From: [Puco ContactOPSB](#)
To: [Puco Docketing](#)
Subject: Public comment: OPSB Case # 18-1607-EL-BGN
Date: Friday, August 28, 2020 11:28:50 AM
Attachments: [What is the criteria that determines the project area of a wind farm project.pdf](#)
[Scan0006.pdf](#)
[Scan0007.pdf](#)
[Scan0008.pdf](#)

Matt,
Please place this in the public comments for OPSB case #18-1607-EL-BGN, Firelands Wind LLC (Emerson Creek Wind Farm).
I am attaching 1 PDF which is the written document, and three scans. The 3 scans are supporting documents. If you have any questions, feel free to respond to this e-mail and I will get back to you as quickly as possible.
Thank you for your time.

What criteria determines the footprint of a wind farm project? Is it determined by the applicant or is the Ohio Power Siting Board responsible to judge the merit of the area of the wind farm footprint?

DIAGRAM 1

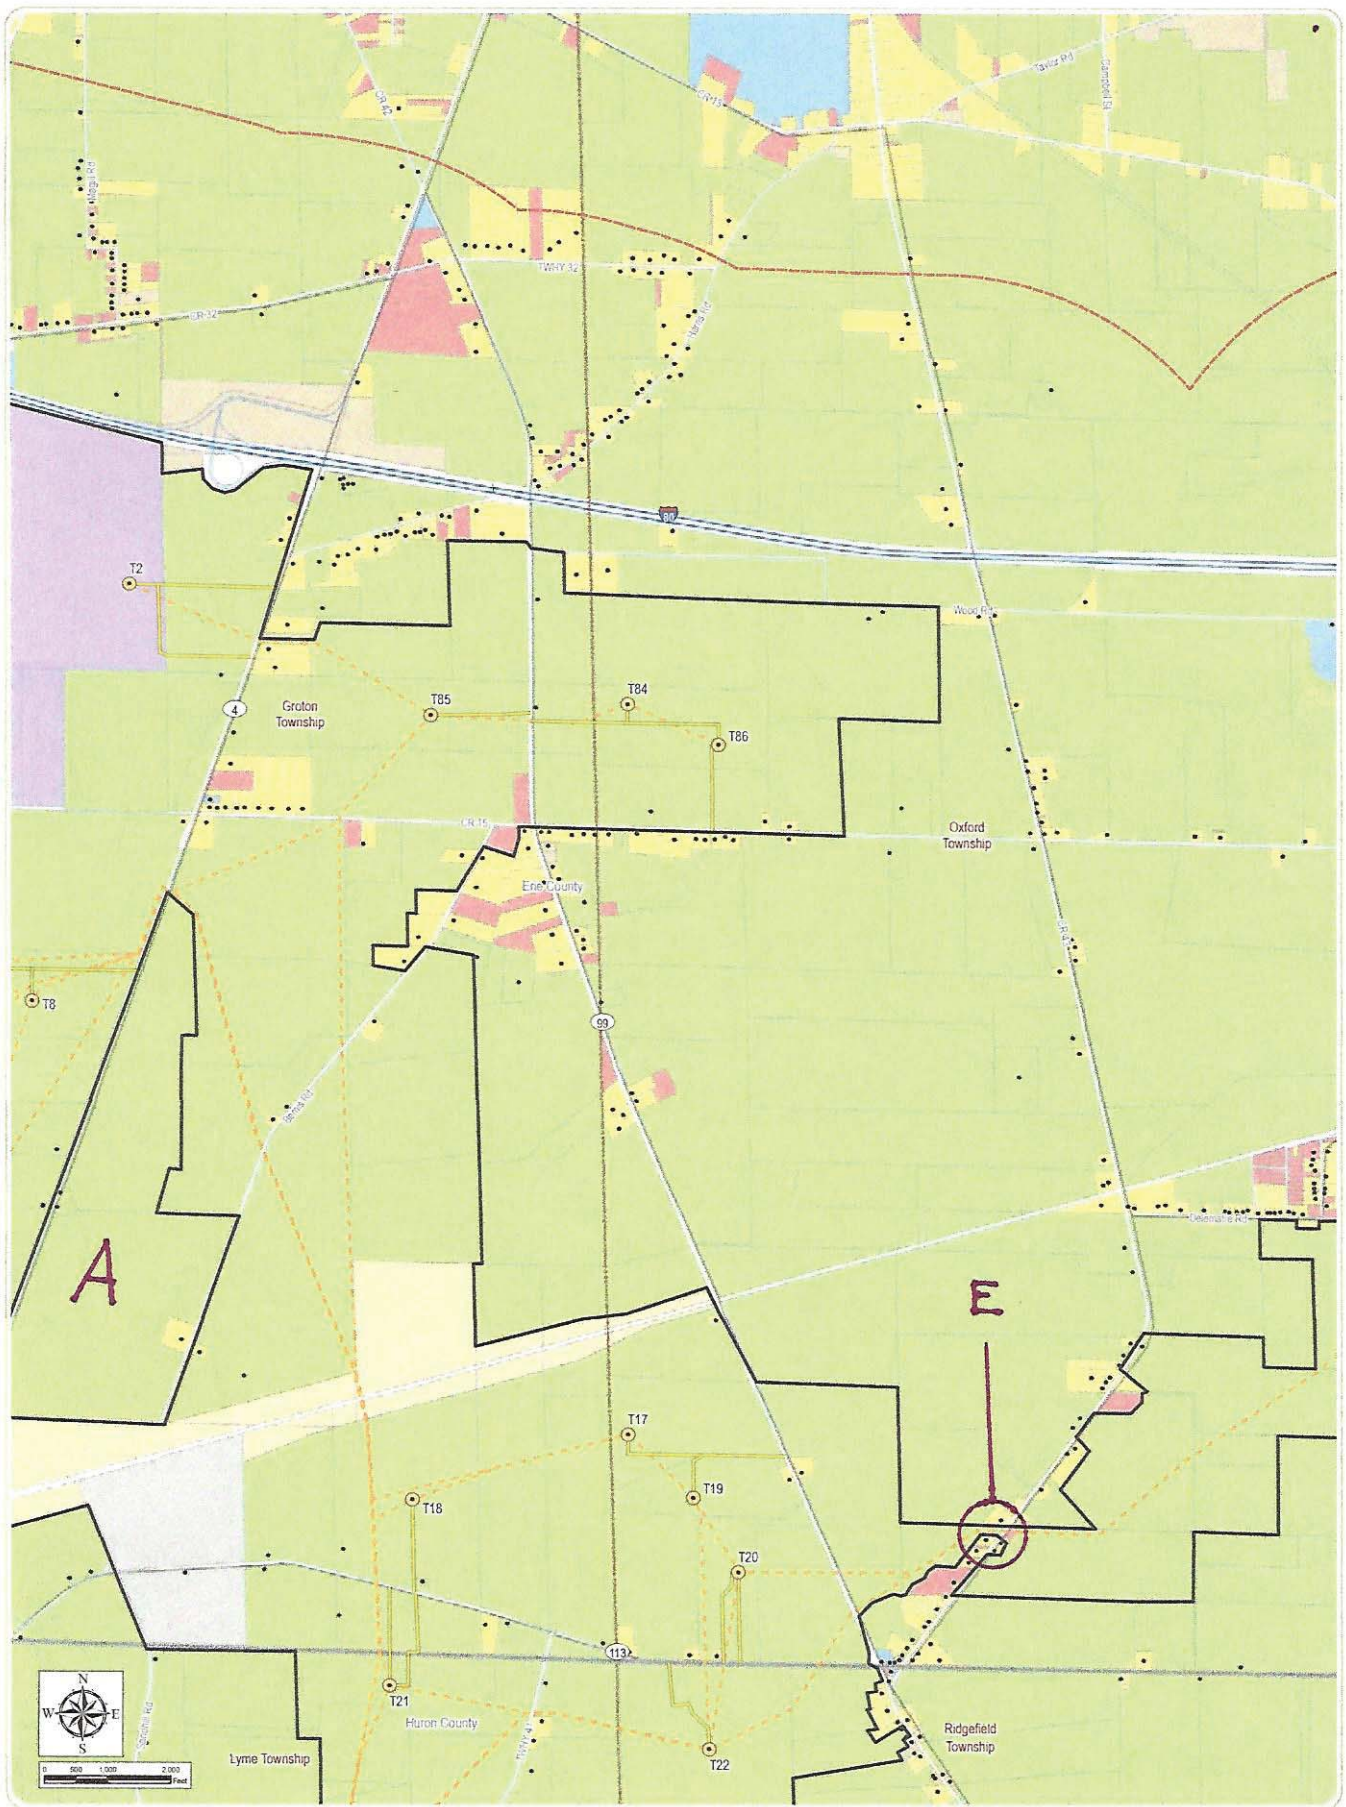
This question seems appropriate after reviewing the proposed Emerson Creek Wind Farm project map. The project map, as seen in **Diagram 1**, has areas in the footprint that are completely surrounded by the proposed project yet are not included in the project footprint. **(Points A, B, C and D)** These areas would be encompassed by turbines, but are not included in the actual wind farm footprint. Residents in these areas are affected by the wind farm as much or more than residents inside the wind farm footprint, but have no legal recourse for intervention in the OPSB process, as they are not in the wind farm footprint.

The city of Bellevue (**Diagram1: as noted**) is projected to have wind turbines on three sides of its perimeter, but is also not included in the wind farm footprint.

There are also sections of this proposed project connected to the rest of the project by strips of land only a couple of hundred feet wide. (**Diagram 1: Points E, F, G, H, and I**)

**DIAGRAM
2**

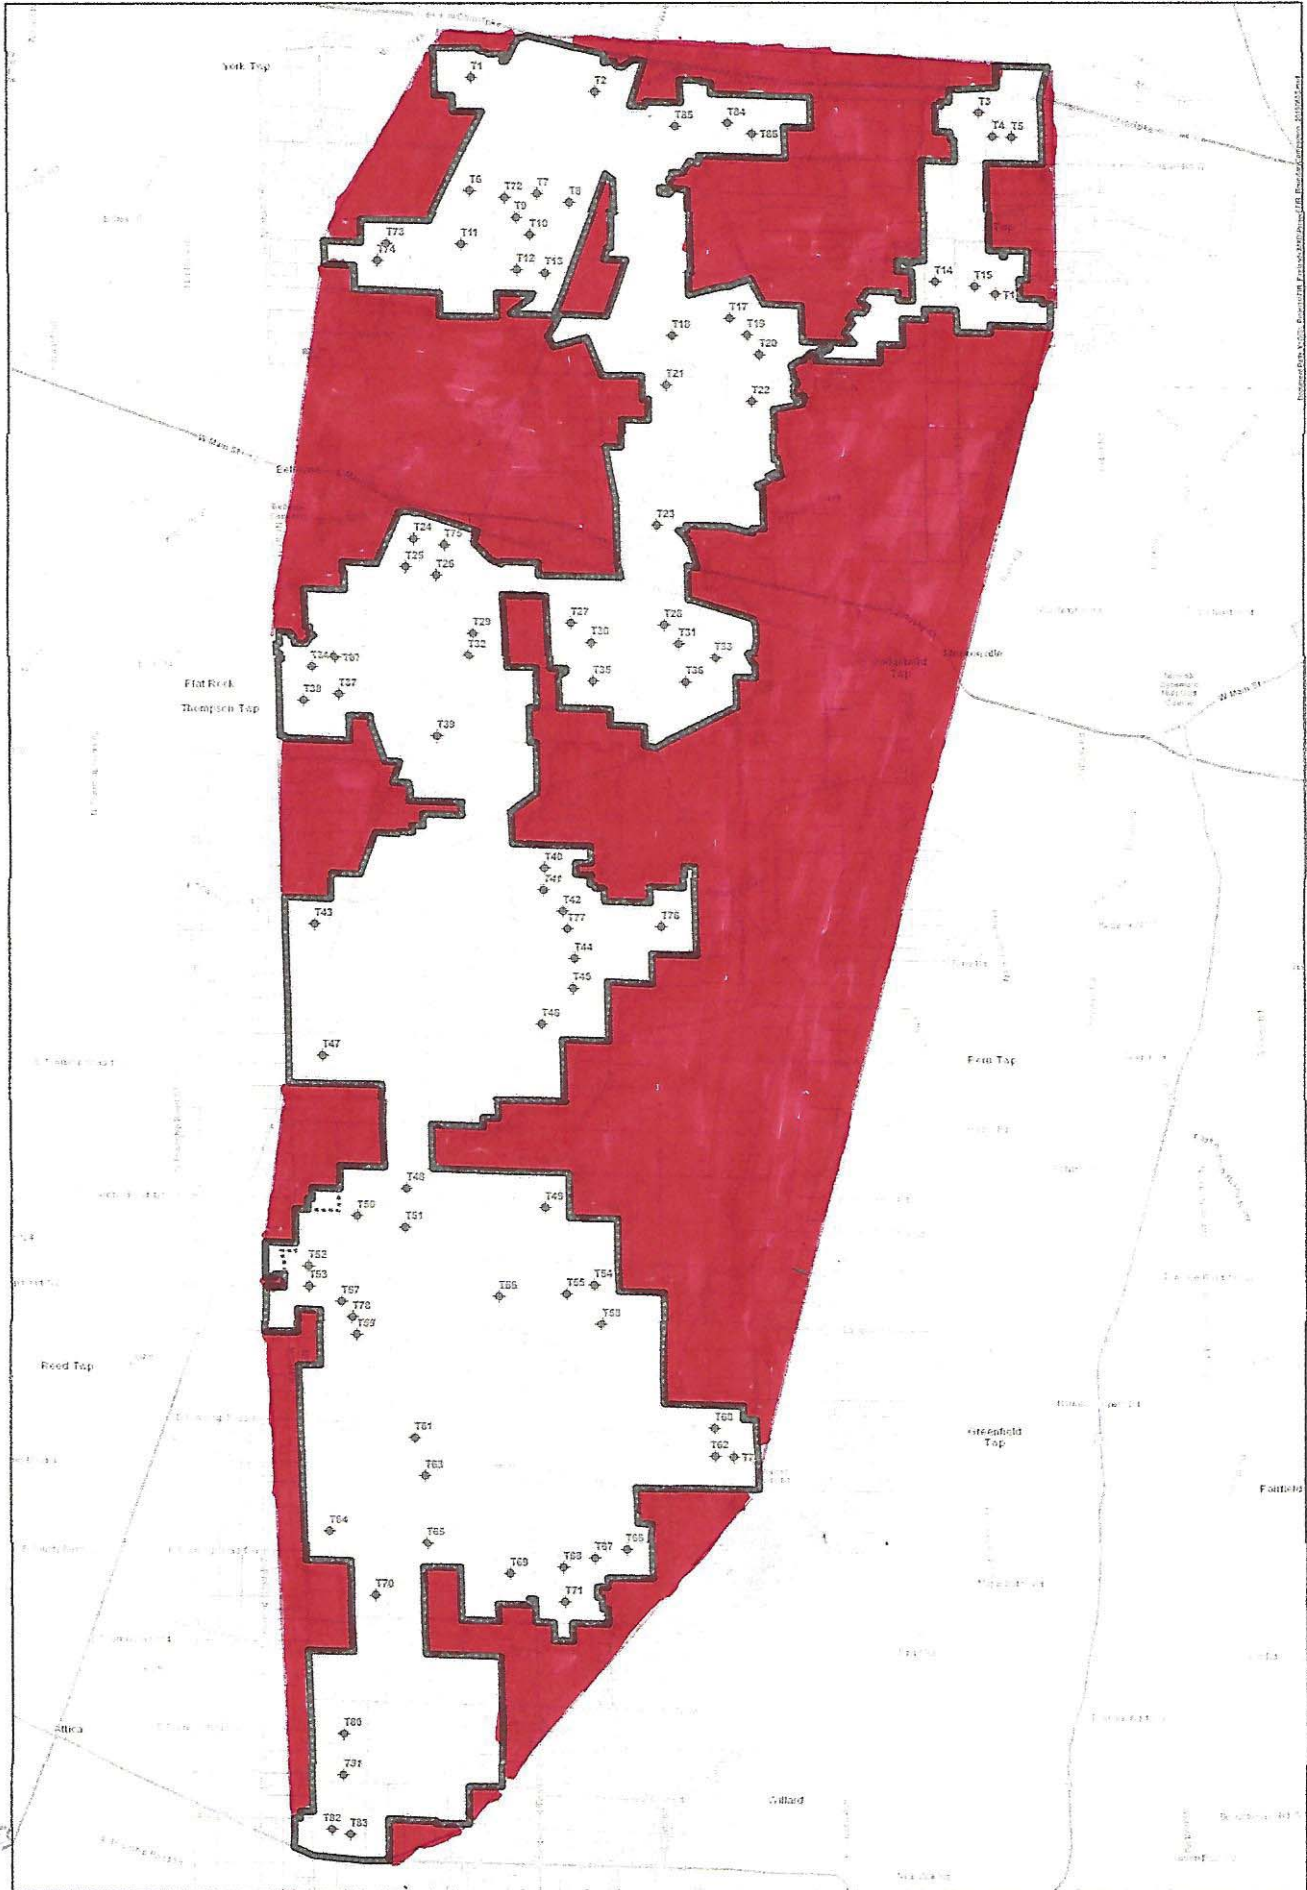
A logical project footprint would have straight line borders connecting the outermost points to one another. With respect to the proposed Emerson Creek Wind Farm, it would look like the representation shown in **Diagram 2**. It would include the present proposed footprint and the area in red.

The total area of this suggested logical project footprint is about 80,000 acres, considerably more than the present proposed project footprint.
